OUR REF: JOB NO. 22113 – S4.55

22 March 2024

**RE: SECTION 4.55 MODIFICATION FOR DEVELOPMENT APPLICATION (DA NO. 477/2022)
NO. 45 WATERSIDE CRESCENT, EARLWOOD**

Figure 2: Approved and Proposed Lower Ground Floor Plan

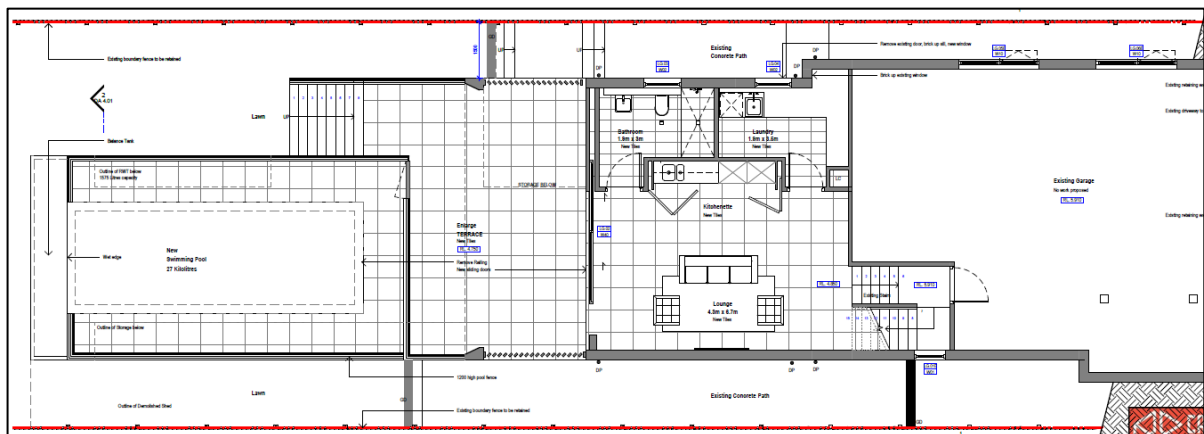
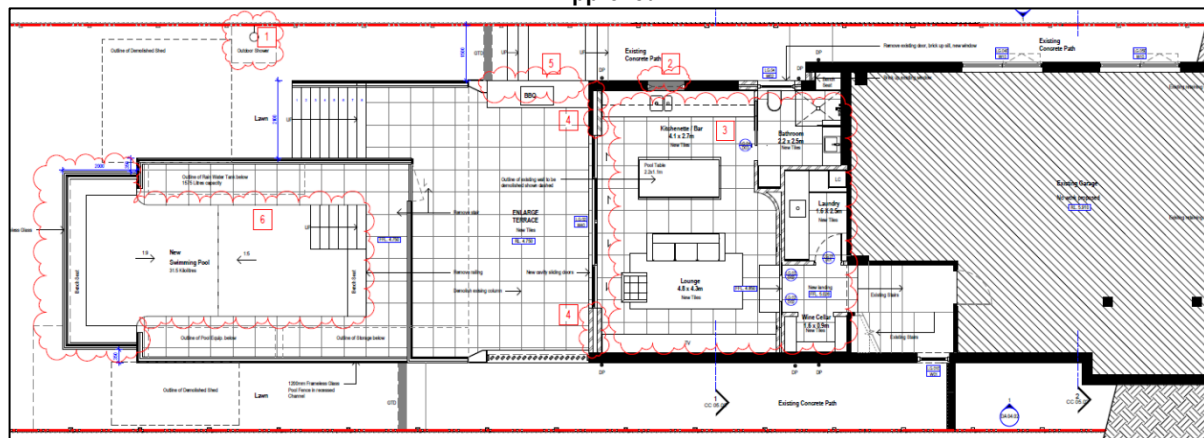
- Internal reconfiguration including modified internal walls. This floor level will continue to contain a bathroom, kitchenette, laundry and lounge room, with a new wine cellar and landing at RL 5.026 proposed;
- An additional portion of the existing external wall demolished to accommodate new cavity sliding doors;
- Deletion of one window;
- Deletion of the eastern external privacy screen;
- New barbeque;
- Modified swimming pool layout and depth; and
- New outdoor shower no higher than the existing fence (see **Figure 2**).

Figure 3: Approved and Proposed Ground Floor Plan

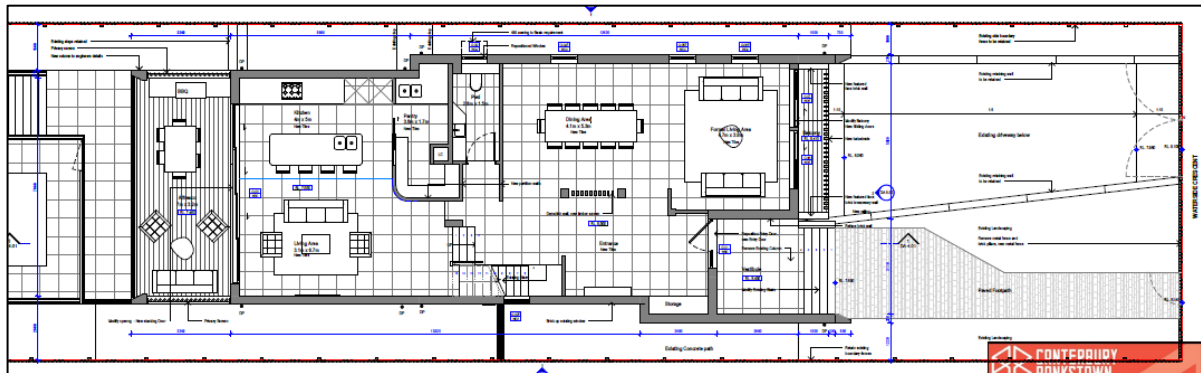
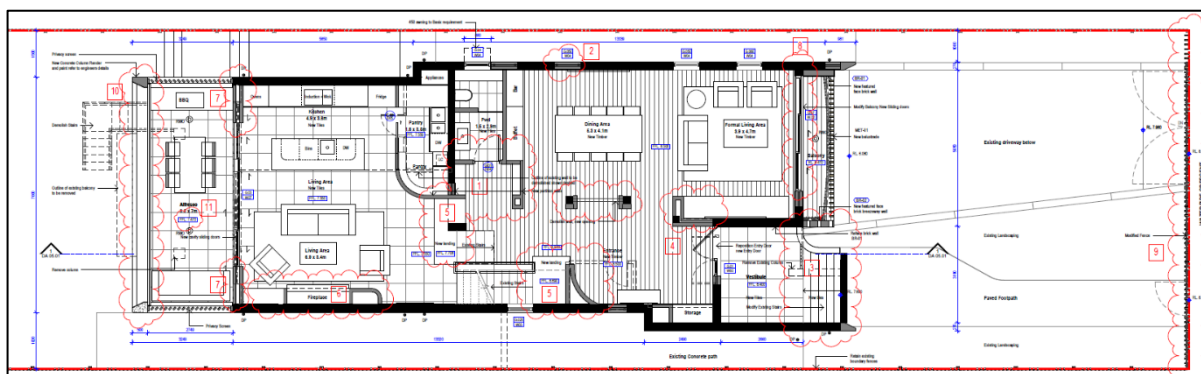
- Revised material of the approved replacement front fence;
- Modified layout of the front entry stairs to accommodate a new curved wall;
- Select internal walls modified;
- Modified powder room and pantry layout;
- New fireplace;
- New landings at RL 7.706 and RL 8.69 to existing internal stairs;
- Infill/remove one existing window;
- An additional portion of the existing external wall demolished to accommodate new cavity sliding doors;
- Slightly altered RL of the alfresco from RL 7.46 to RL 7.47 to correct a minor error when compared to the approved plans; and
- Alfresco balustrade set back to accommodate the modified structural edge beam (see **Figure 3**).

Figure 4: Approved and Proposed First Floor Plan

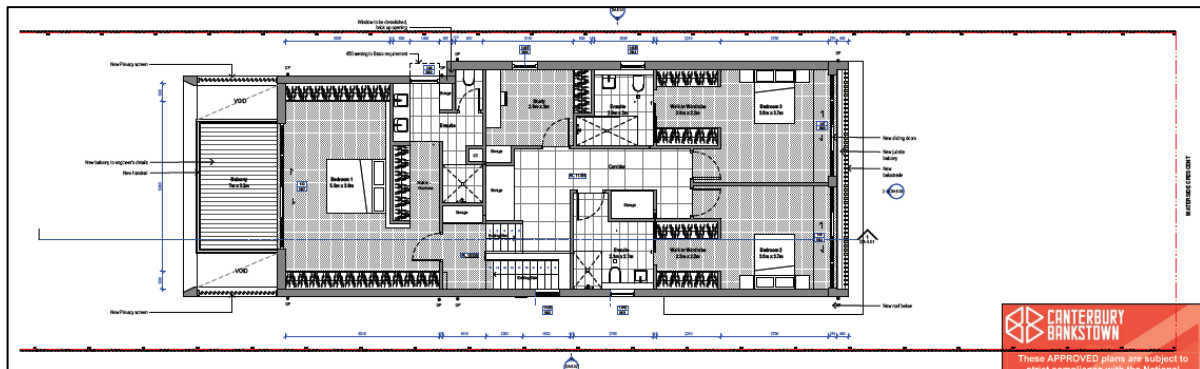
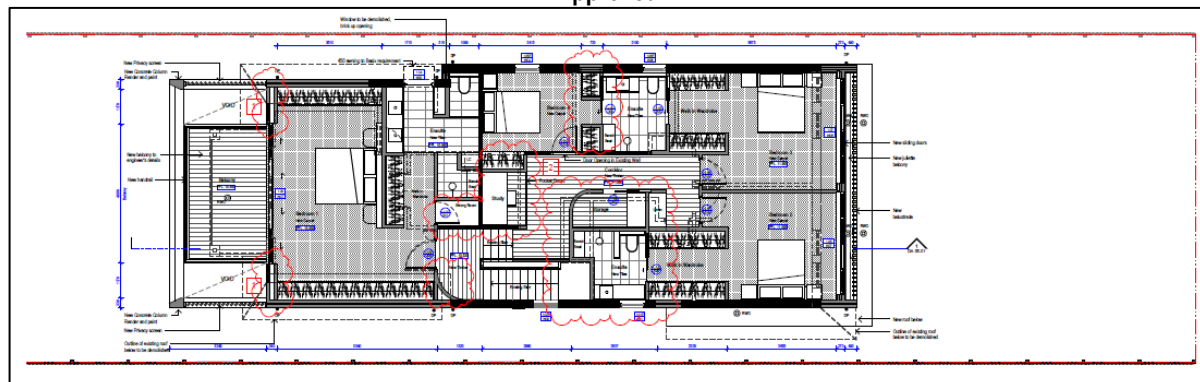
- Internal reconfiguration including modified internal walls. The approved study will become a fourth bedroom, which reverts the dwelling to the same number of bedrooms as existing. The approved Bed 3 ensuite will be modified to connect with Bed 4. The study will be relocated elsewhere on this floor level; and
- An additional portion of the existing external wall demolished to accommodate new cavity sliding doors (see **Figure 4**).

Figure 5: Approved and Proposed East and West Elevations

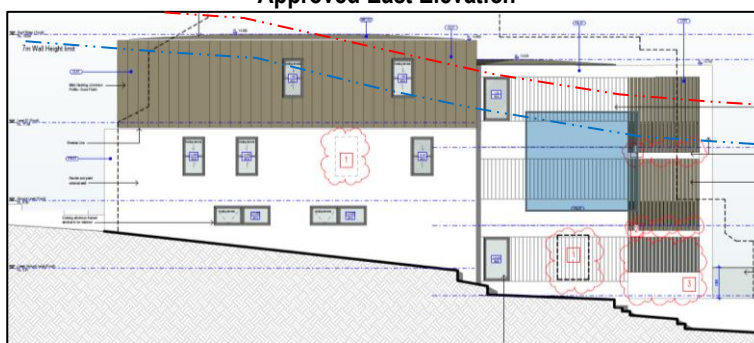
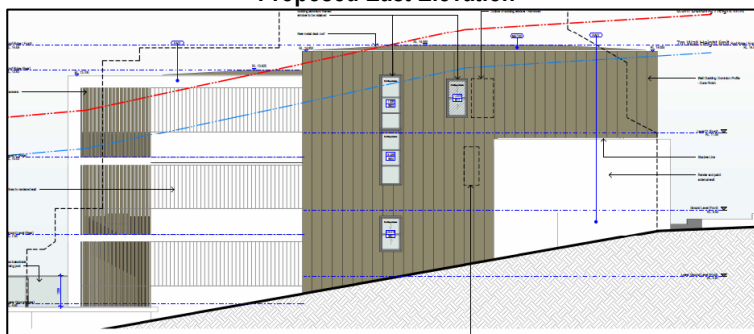
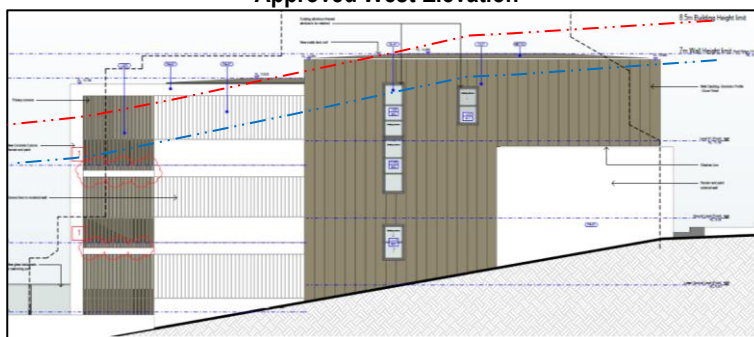
- Modified concrete edges and privacy screens extended (see **Figure 5**).

Figure 6: Approved and Proposed South (Front) Elevation

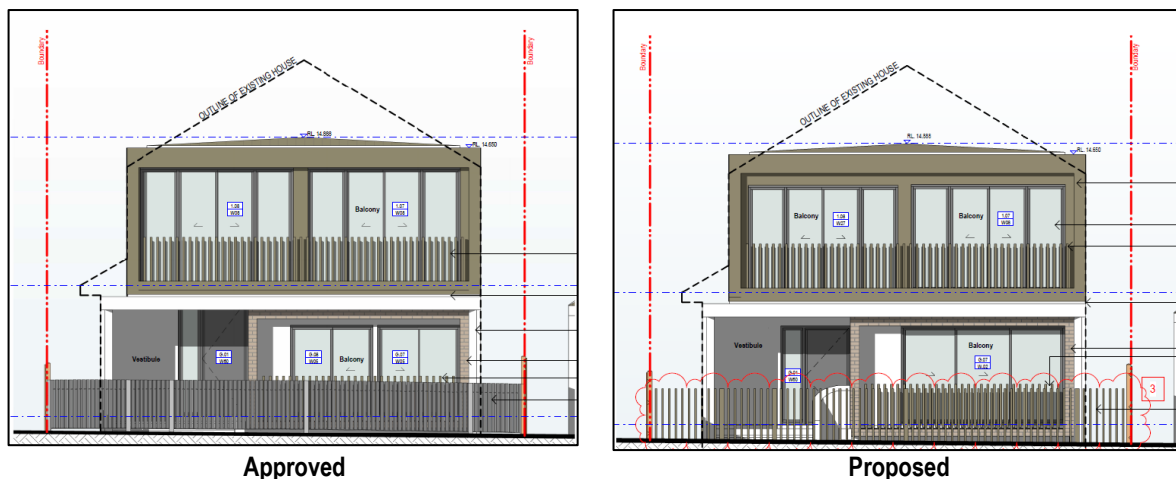
The proposed modifications to the front façade when compared to the approval are limited to a modified front fence design and a new curved wall next to the entry stairs (see **Figure 6** on the following page). The front fence will offer improved visual consistency with the approved dwelling, particularly with the approved first floor balustrades. The curved wall will have a neutral to positive impact on the dwelling's streetscape appearance.
